Subject:
Addendum to VRRP Interim Measures Work Plan
Freedom Industries Etowah Terminal
Charleston, Kanawha County, West Virginia,
VRP #15017

FREEDOM INDUSTRIES
1015 BARLOW DRIVE, CHARLESTON, WEST VIRGINIA
OH003003.0001

FIGURE
1

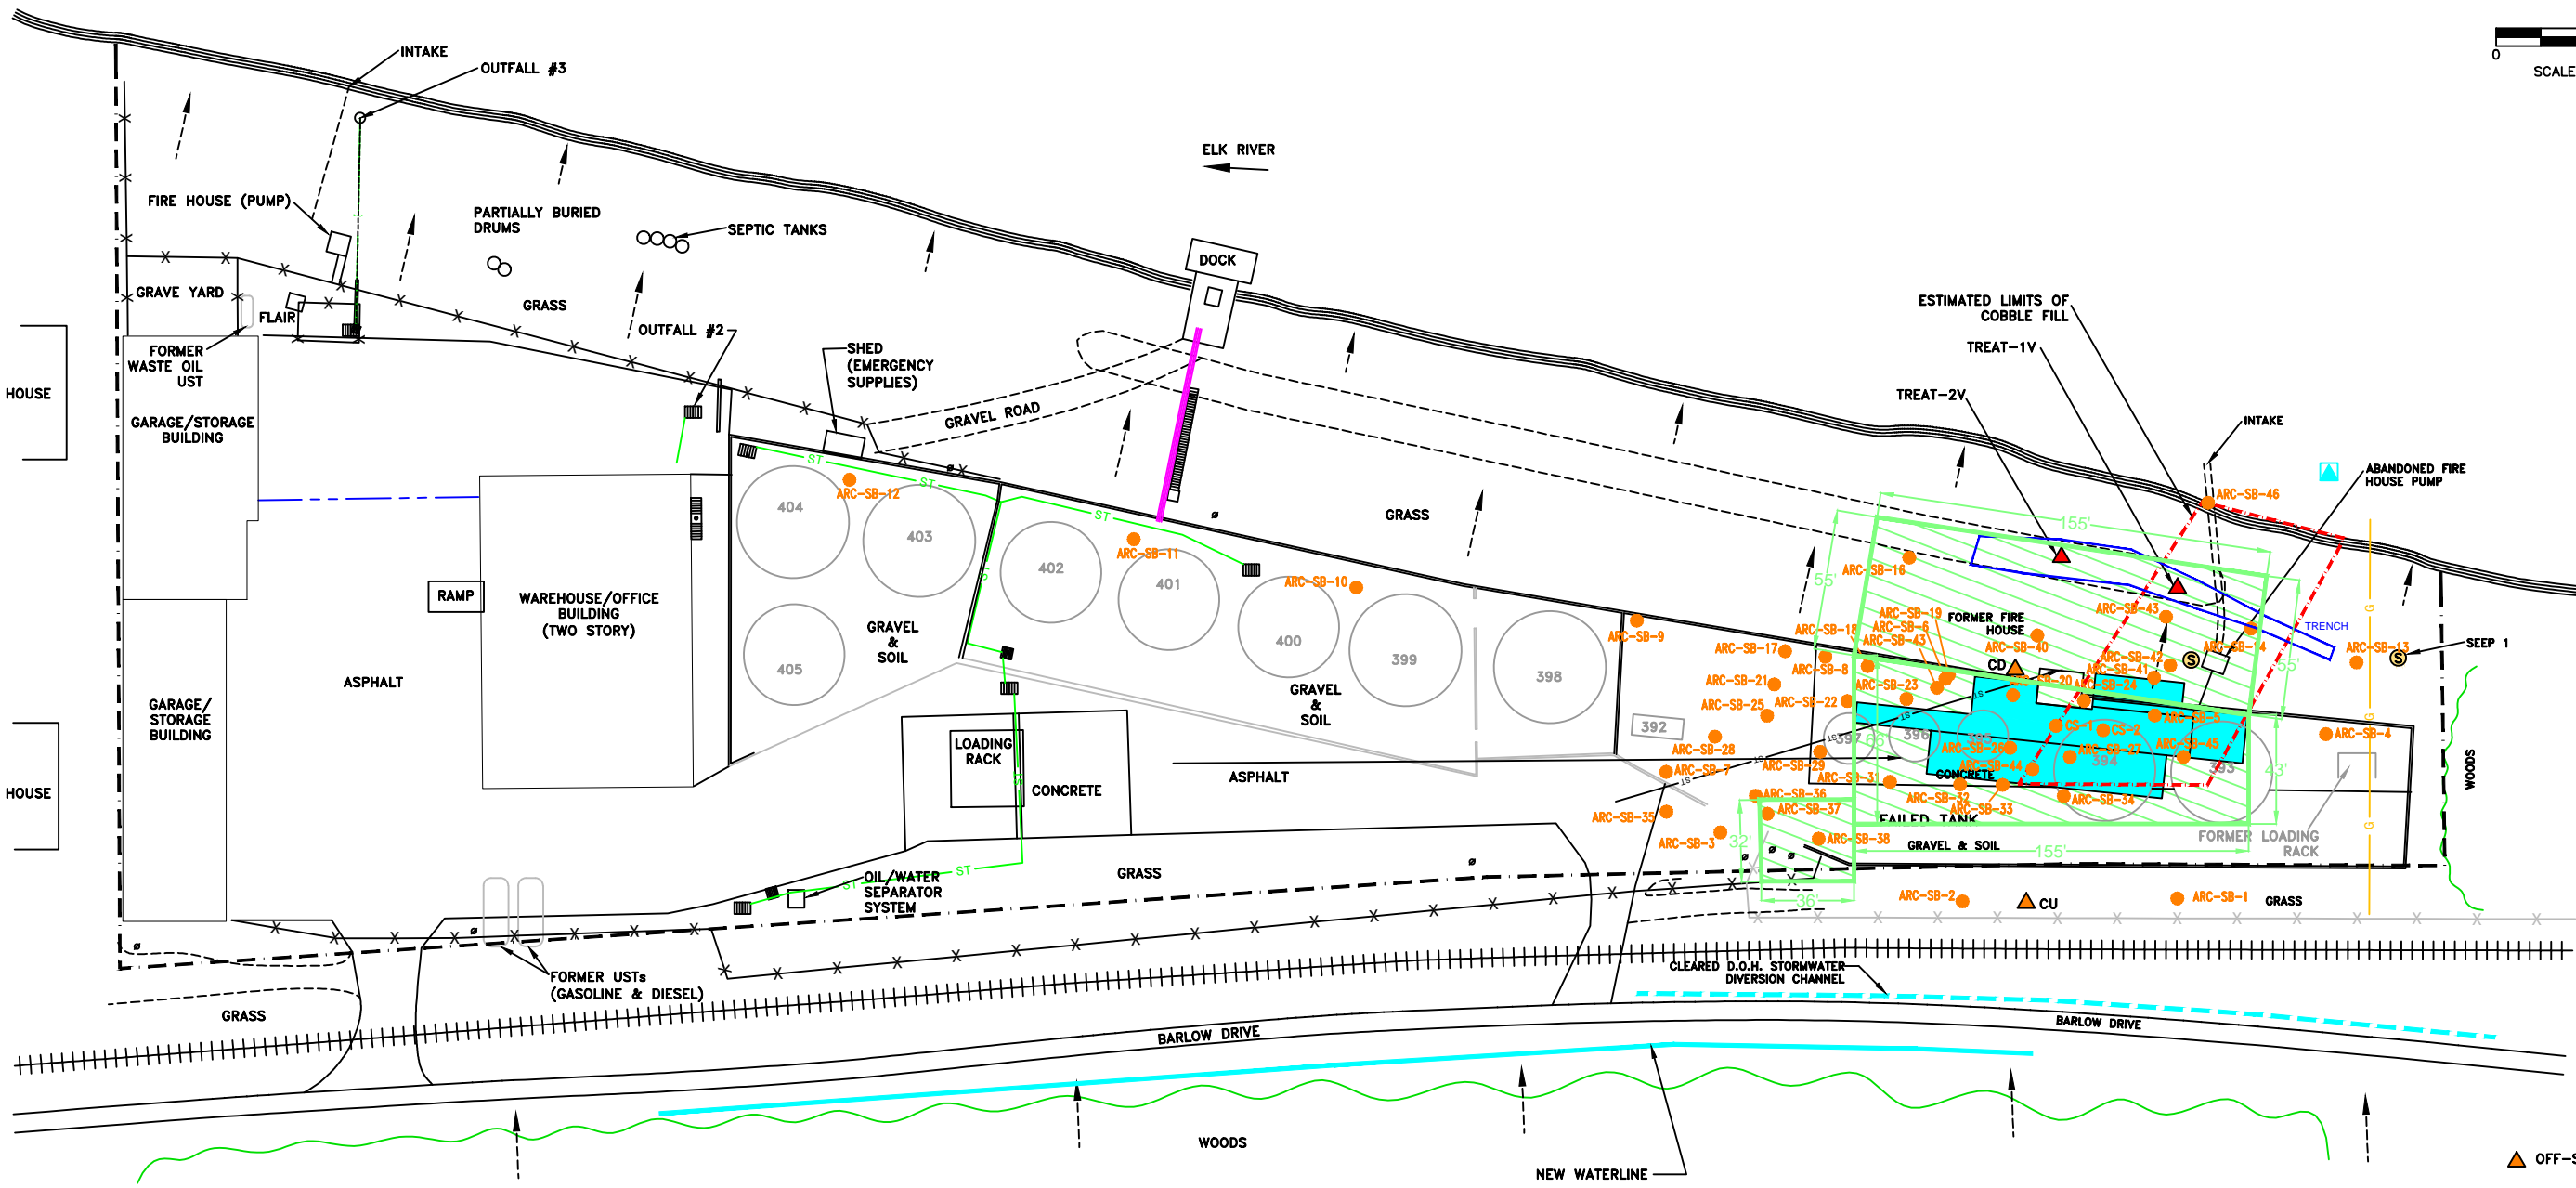
5. Provide information on any proposed excavation and confirmatory sampling activities, including areas to be excavated, amounts estimated, confirmatory sampling protocol, etc.

It should be noted that the soils most impacted by MCHM has already been excavated and disposed of offsite. Confirmation soil samples have been collected from these excavations and remaining soils which are impacted exhibit significantly lower concentrations. Since the existing trench is likely impacted with trace amounts of MCHM the first phase should be to cover the existing trench with plastic, install a new trench adjacent to the existing trench, and monitor the newly installed trench.

In the event MCHM impacted water is detected in the new trench, ARCADIS proposes that an excavation be completed. **Figure 1** details the potentially impacted soil along the spill pathway. The excavation will exclude areas that have previously been excavated and will focus on the slope and preferential pathways. The minimum digging depth will likely be two feet below grade; however, if gross MCHM impacts are encountered, excavation will continue to remove them. This excavation will also focus on the highest known soil impacts within the former tank area. Confirmation soil samples will be collected for the chemicals of concern for the site. The confirmation soil samples will be collected at the deepest points of the excavation and there will be at least one confirmation soil sample for every 400 square feet of area or 20 by 20 grid based approach. Due to the time constraints, a figure depicting the confirmation sampling rational is not available. Upon completion of the excavation, the excavated area will be back filled with a clean, impermeable fill (clay) to eliminate precipitation from contacting MCHM impacted media, as well as reduce infiltration in the former tank area as well as the sloped spill area. The backfill will be analyzed for MCHM, PPH, Glycols, VOCs, SVOCs and metals and will not be used if impacts are detected.
